BRIDGE REPLACEMENT - PPCB

NEW DUAL BRIDGES AS PART OF 4 LANE US 20 PROJECT OVER BOYER RIVER 1.9 MILES WEST OF US 71

REVISION EXAMPLE

NOTICE: This plan revision example is in the MicroStation V8i format of CADD sheets and differs from the MicroStation CONNECT format of CADD sheets. The relevant part of this example to focus on is the use of the revision cloud, crossed out text and details, and the use of the revision triangle.

STAKING DIAGRAM

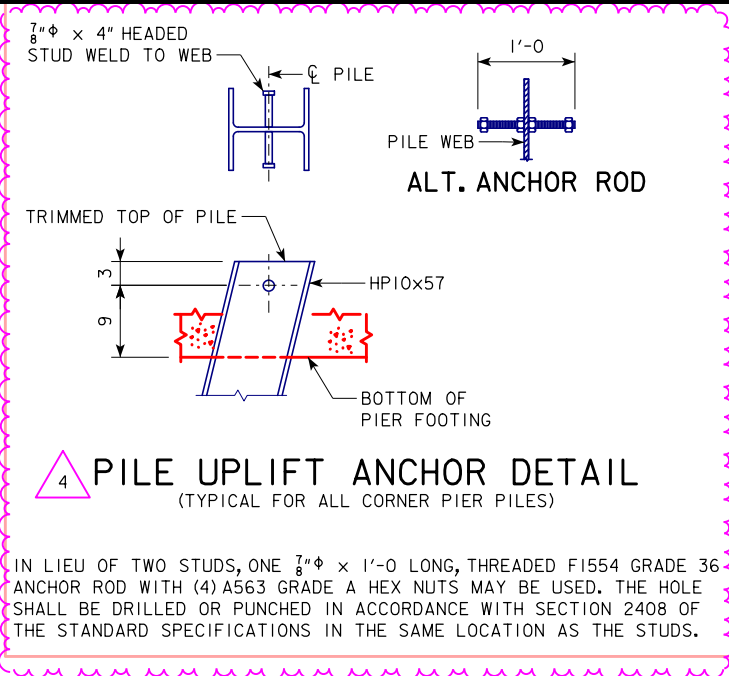
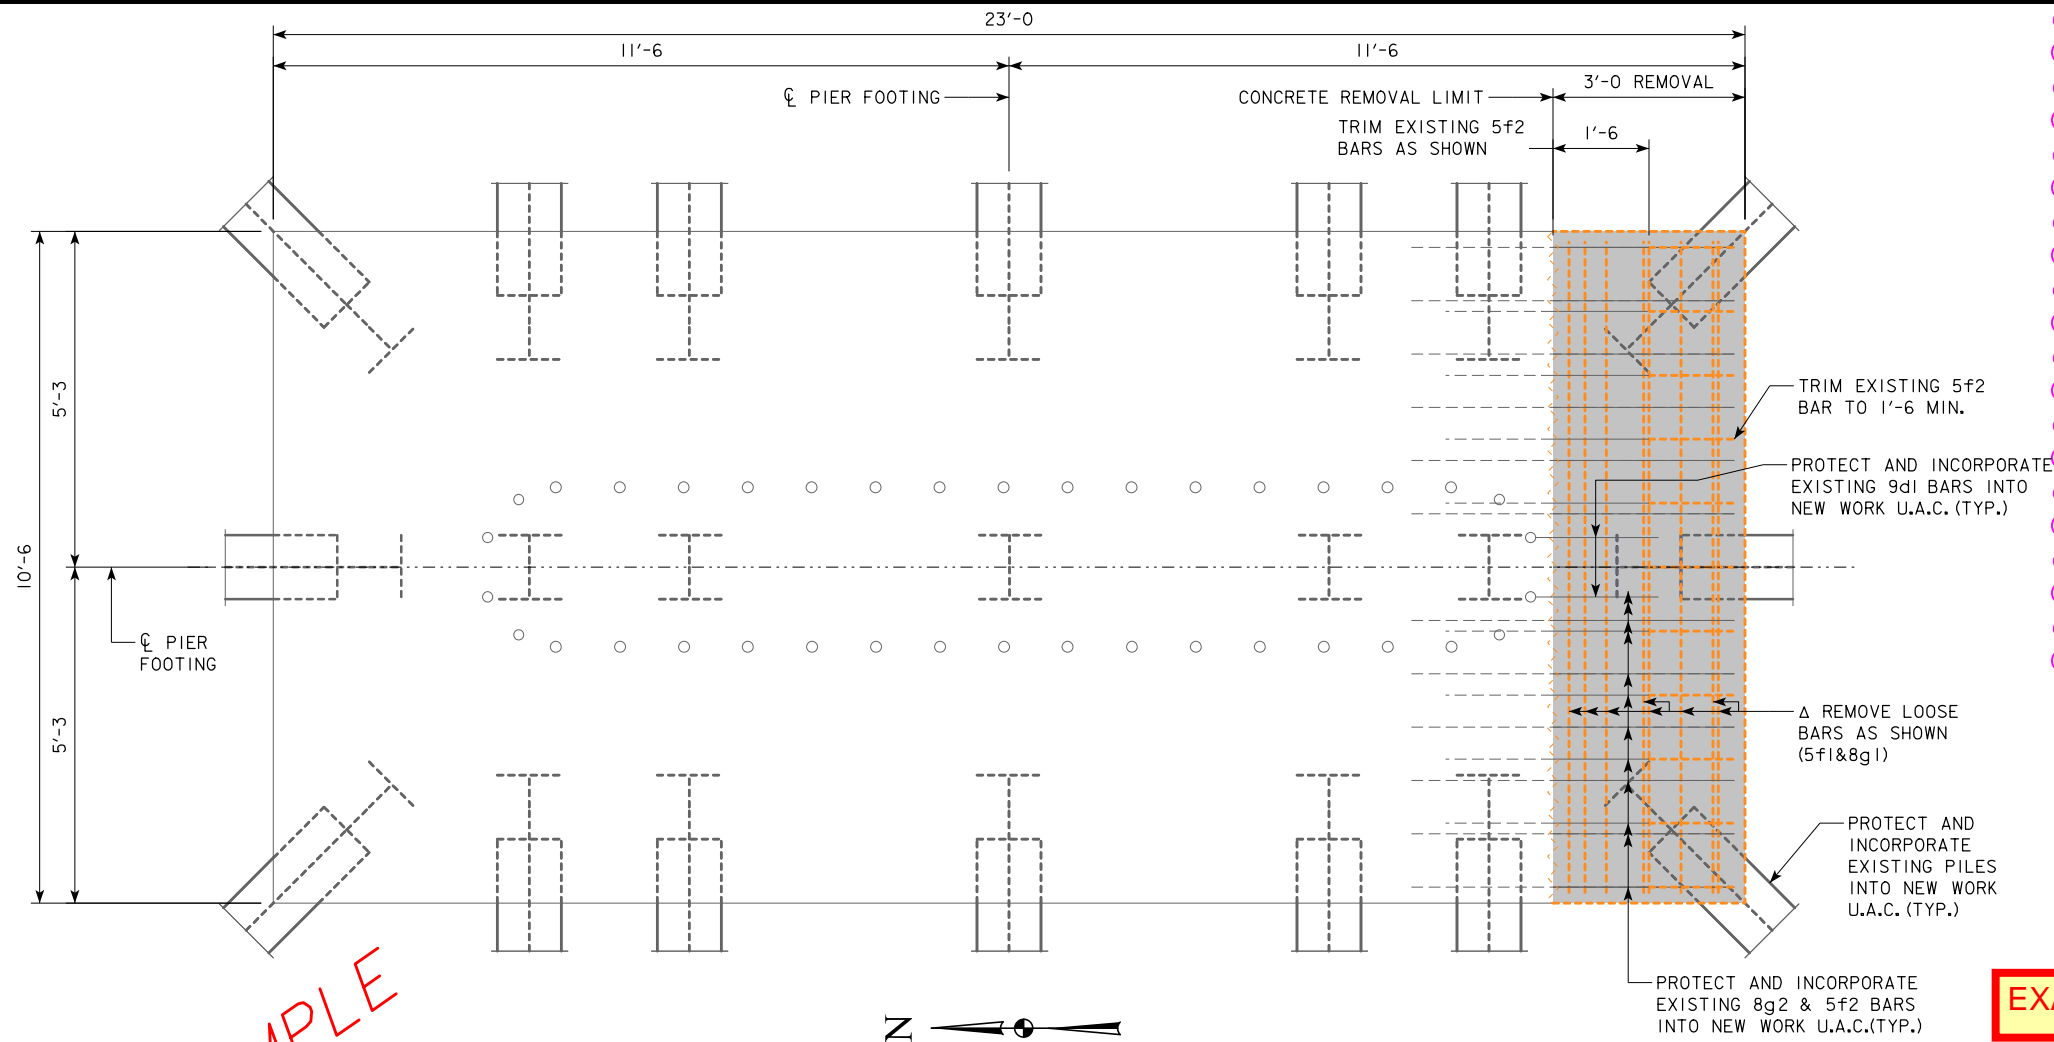
- 4 REVISED: 04-15-2017 REMOVED 2'-0" x 2'-0" CORNER OF PIER 1.
REASON: CORNER REMOVED TO ALLOW CLEARANCE FOR MSE WALL.
- 3 REVISED: 04-11-2017 LENGTHEN ABUTMENTS 10" TO THE NORTH.
REASON: ADDED SIDEWALK TO BRIDGE.

- 2 REVISED: 03-27-2017 CHANGED PIER 2 LOCATION.
REASON: PIER 1 FOOTING SIZE CHANGE DUE TO SURVEY ERROR.
- 1 REVISED: 03-09-2017 CHANGED PIER 2 LOCATION.
REASON: PIER 2 FOOTING MISPLACED 1.4 FT. NORTH OF PLAN ALIGNMENT DUE TO CONSTRUCTION SURVEY ERROR.

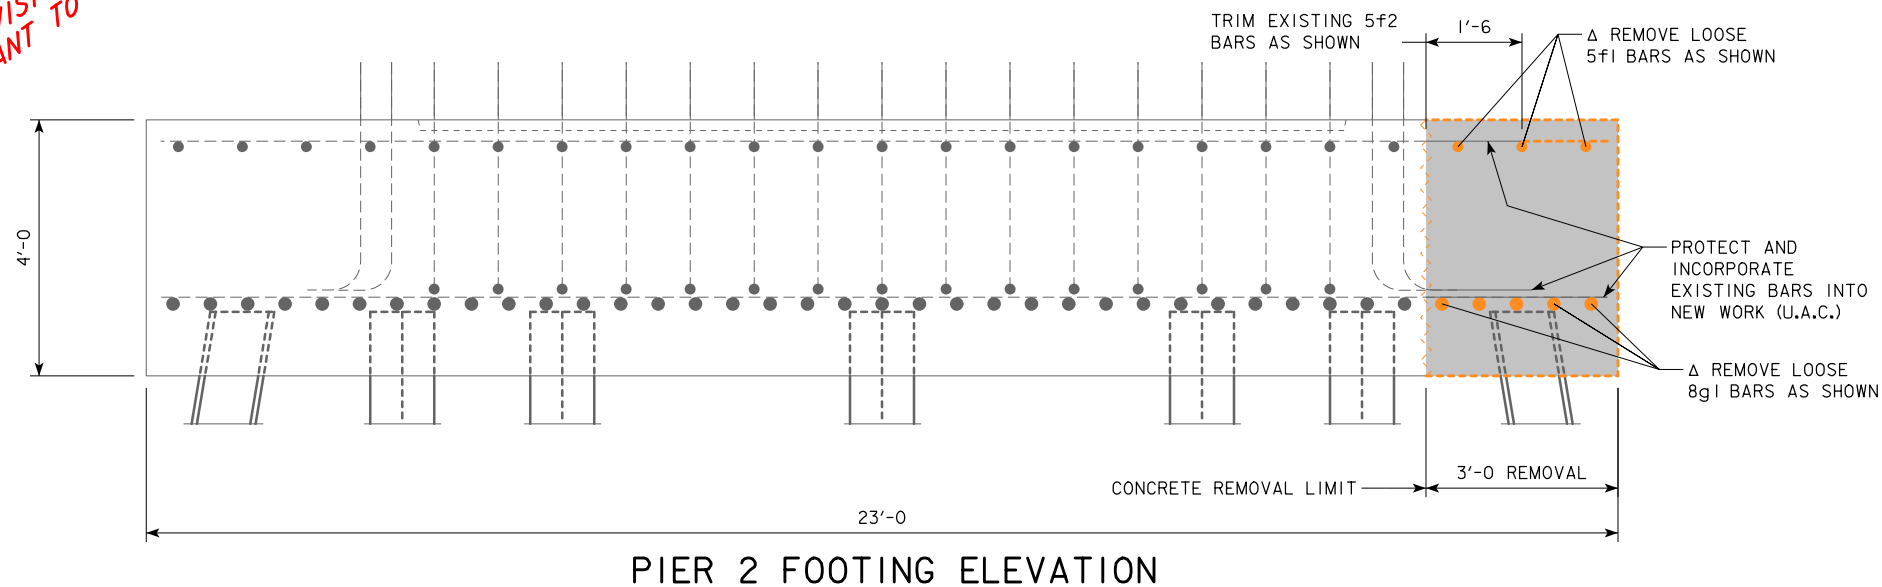
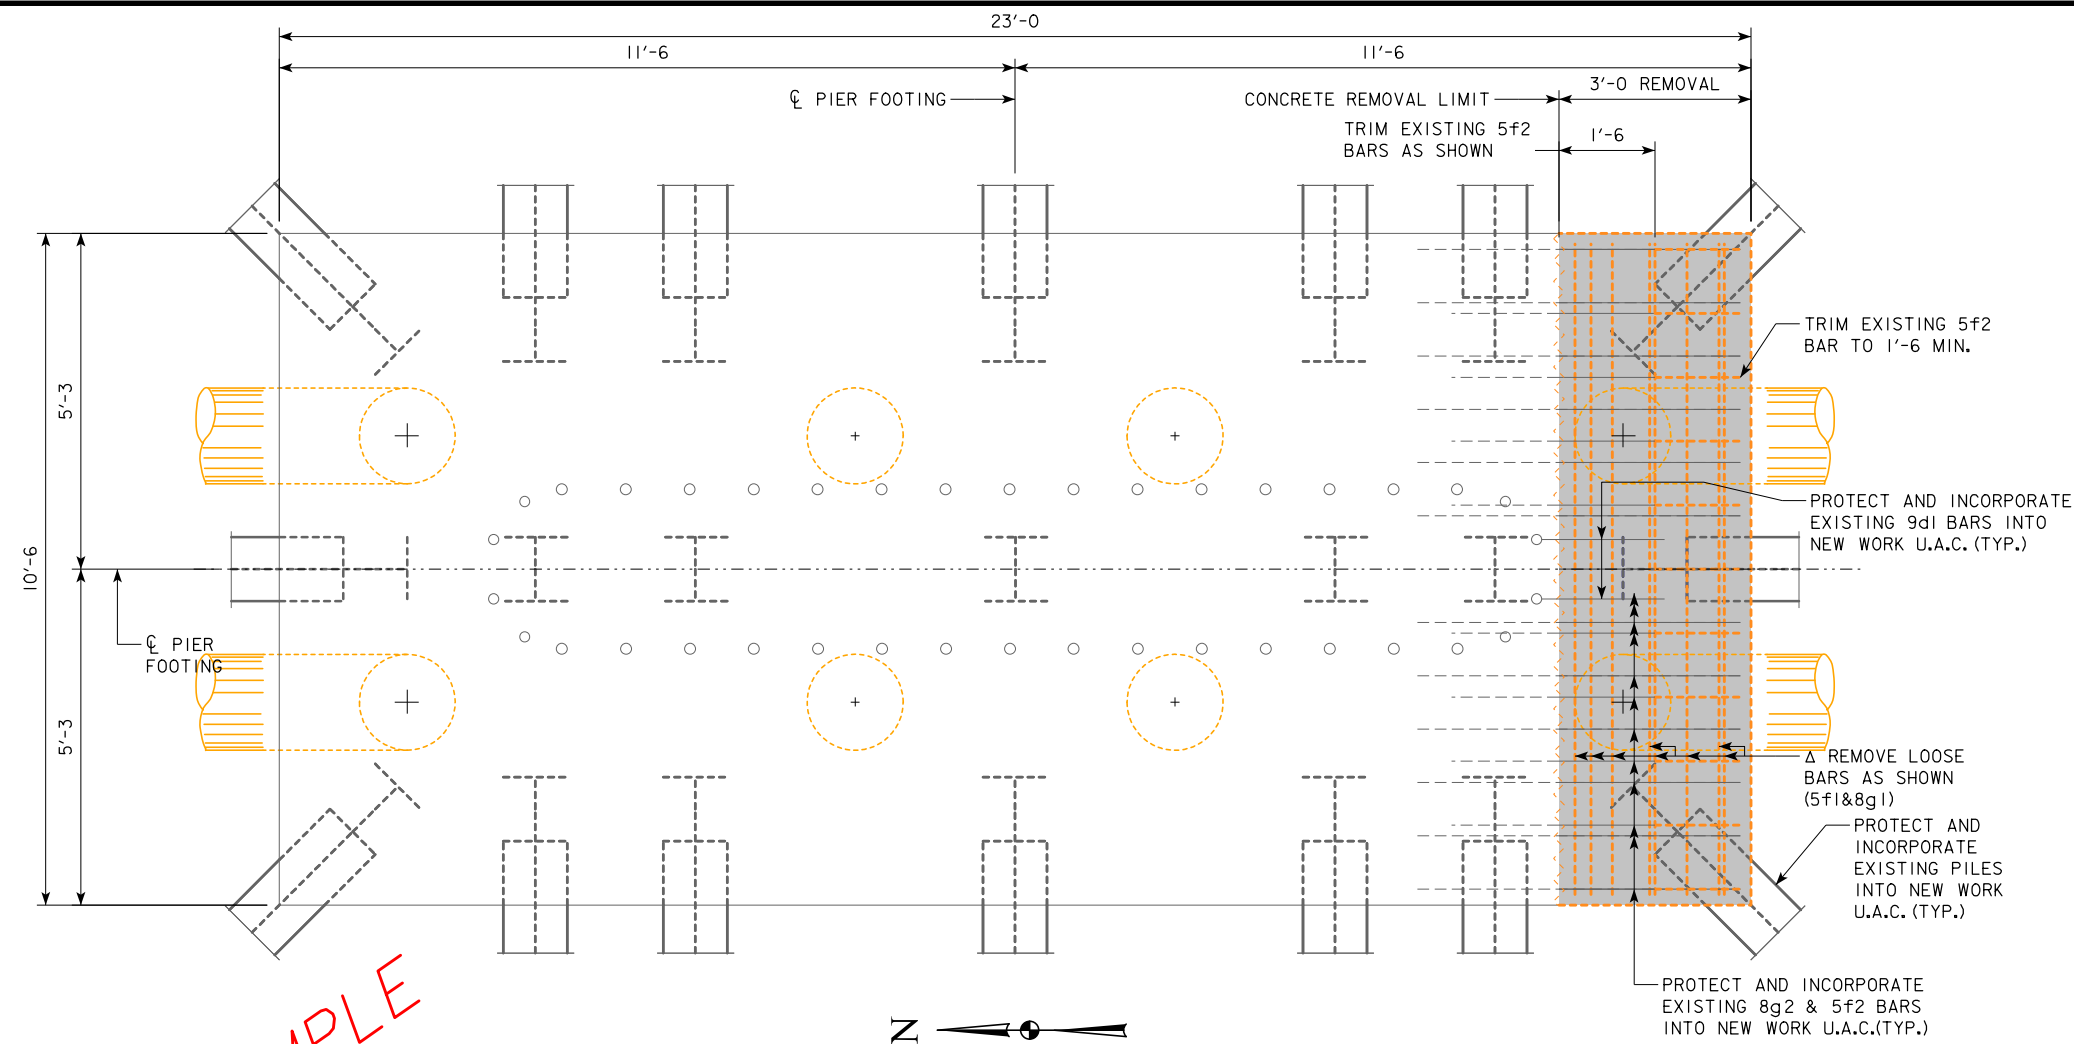
4 REVISED: 04-15-2017 PILE UPLIFT ANCHOR DETAIL ADDED.
REASON: ANCHOR DETAIL NEEDED FOR ADDITIONAL REQUIRED PILES.

Δ LOOSE BARS 5f1 & 8g1 MAY BE CLEANED AND INCORPORATED INTO THE EXISTING FOOTING AS APPROVED BY THE ENGINEER.

1 REVISED: 03-09-2017 THIS SHEET ADDED.
REASON: PIER 2 FOOTING MISPLACED 1.4 FT. NORTH OF PLAN ALIGNMENT DUE TO CONSTRUCTION SURVEY ERROR.

PIER 2 PLAN

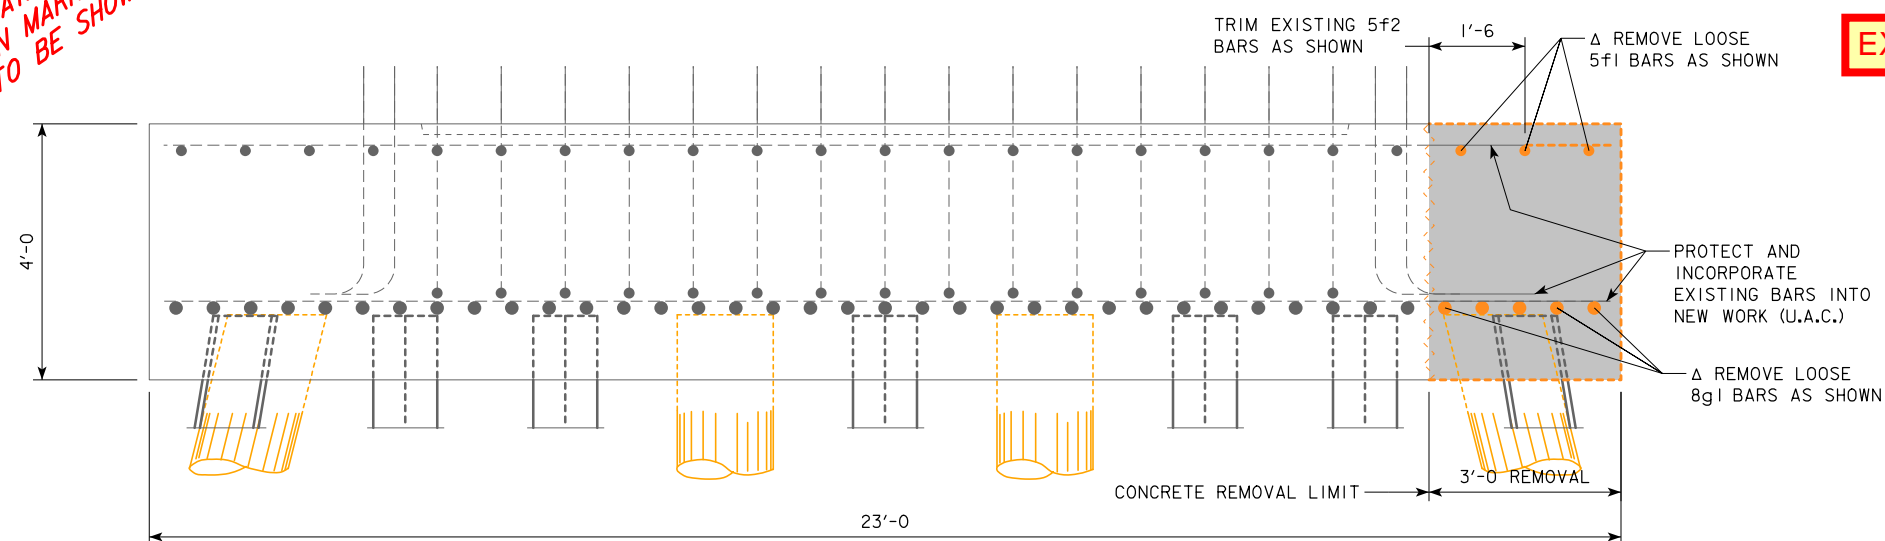
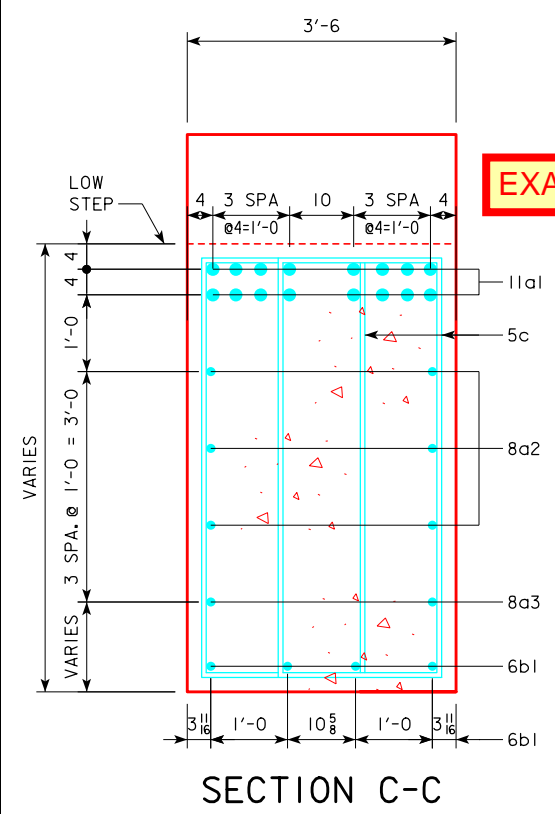
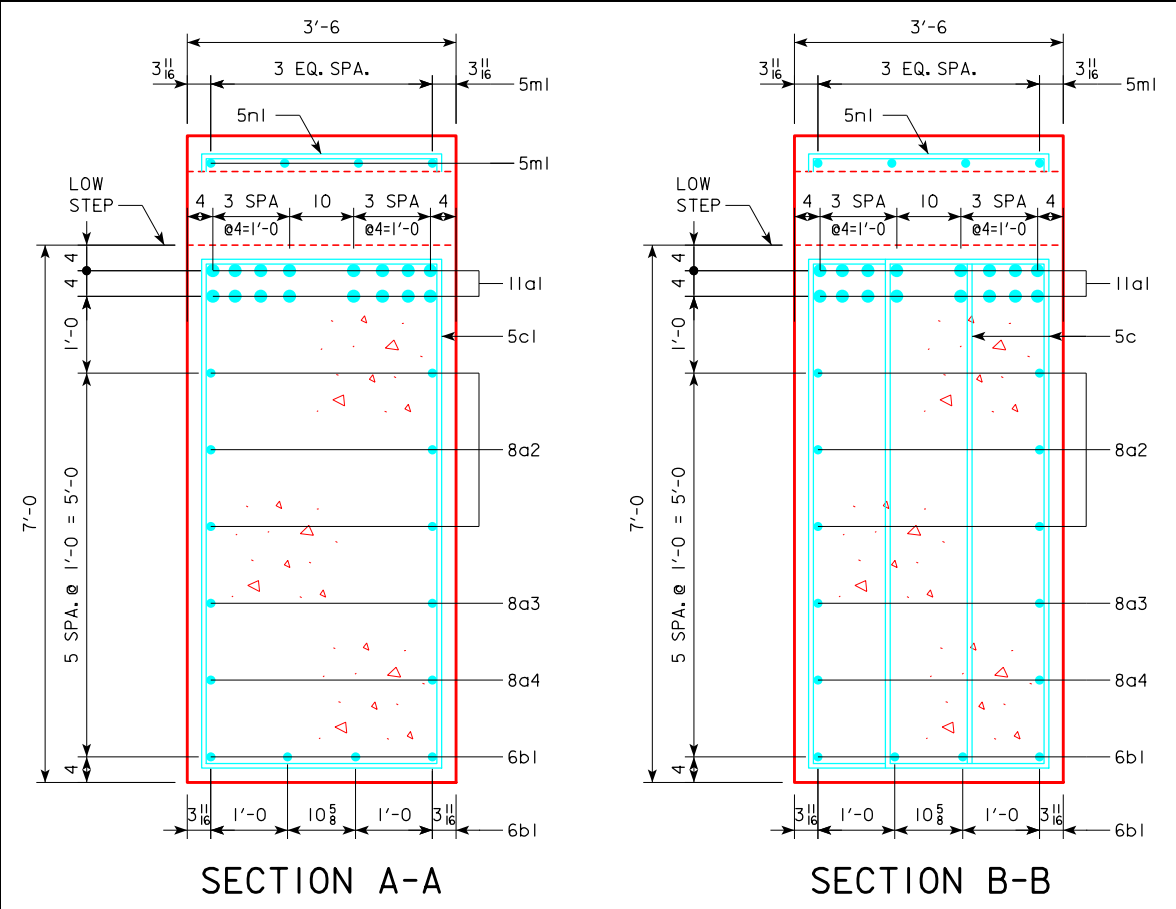
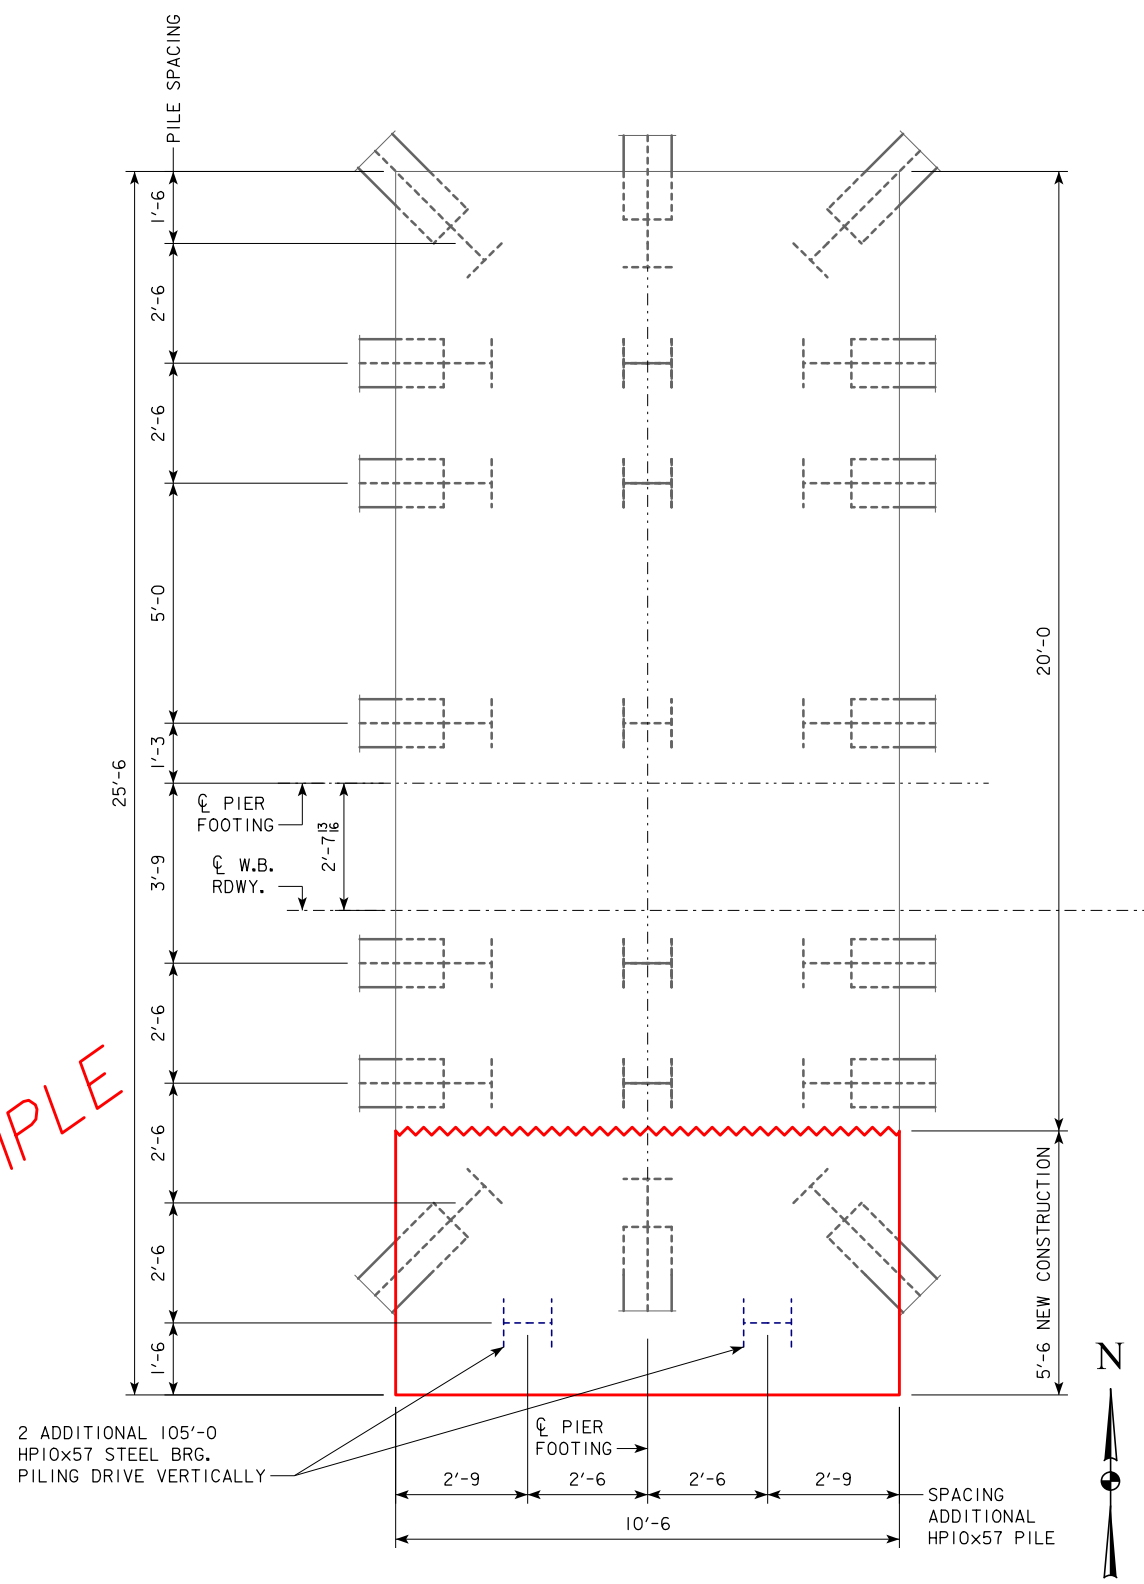
4
REVISED: 04-15-2017 THIS SHEET ADDED.
REASON: WOOD PILES WERE ADDED TO FOOTING FOR ADDITIONAL SUPPORT.
